Product Change Notification: CAAN-09AFAD800

CCB 6887 Final Notice: Qualification of MTAI as an additional In-House Programming (IHP) site for selected M2GL005x, M2GL010xx, M2GL025xx, M2GL050xx, M2GL060xx, M2GL090xx, M2GL150xx, M2S005x, M2S010xx, M2S025xx, M2S050xx, M2S060xx, M2S090xx and M2S150xx device families available in various packages.

Final Notification

Manufacturing Change

CCB 6887
Pre and Post Change Summary
PCN #:CAAN-09AFAD800

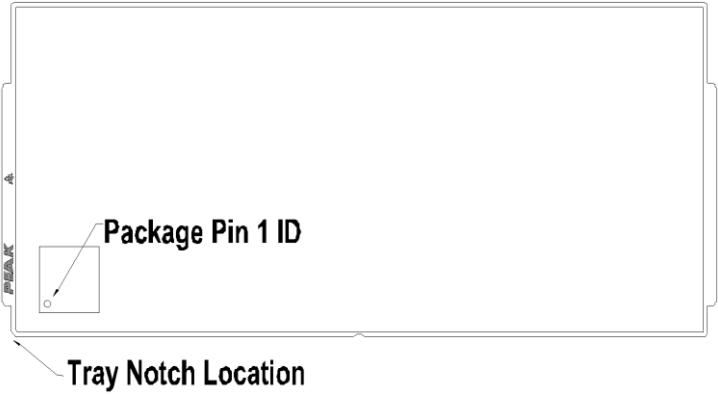
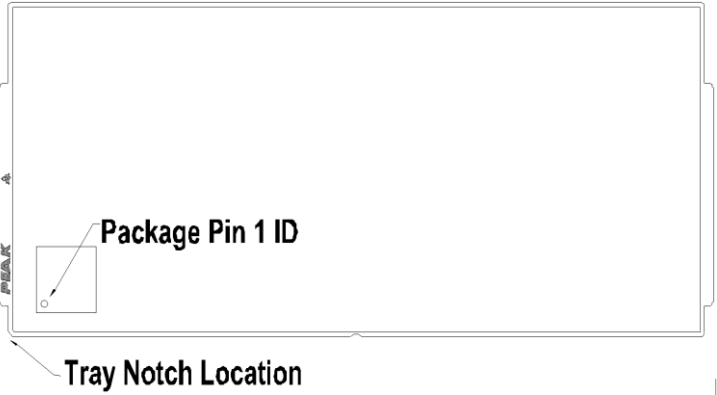
Pre Change	Post Change	
In-House Programming Site	Microchip Technology San Jose (MSCS)	Microchip Technology San Jose (MSCS)	Microchip Technology Thailand (HQ) (MTAI)
Packing Method	See Pre and Post Change Comparison
